Midway City Council
13 June 2018
Regular Meeting

Resolution 2018-13 /
Whitaker Annexation Amendment

CITY COUNCIL MEETING STAFF REPORT

NAME OF PROJECT: Whitaker Farm

Intersection Concept: Memorial Hill & River Road

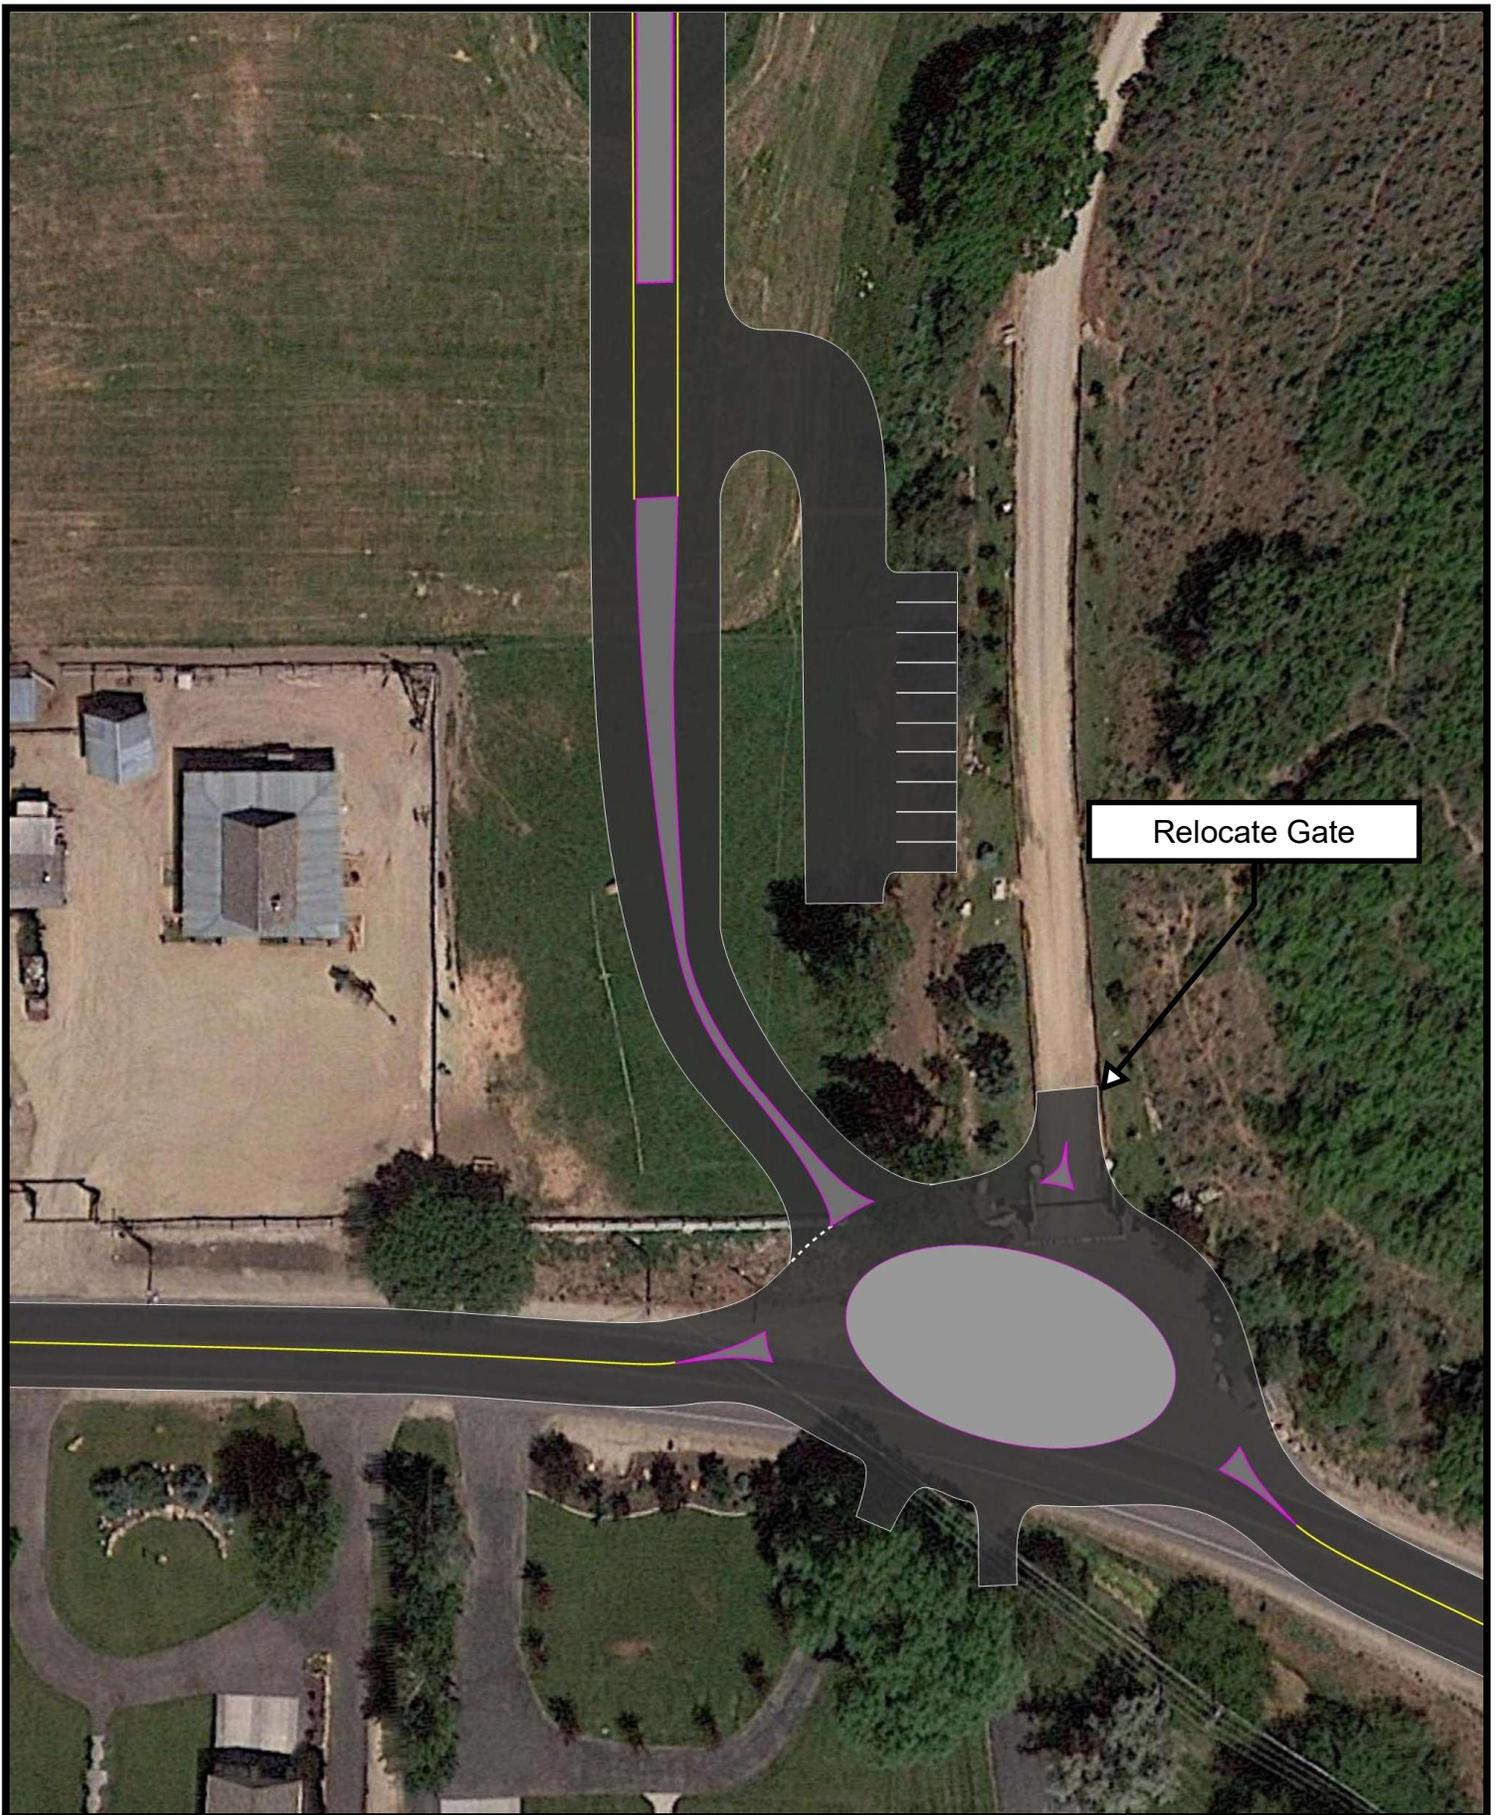
- Constant flow/safer
- Traffic calming
- Beautification/old world

→ Three roundabouts on River Road??
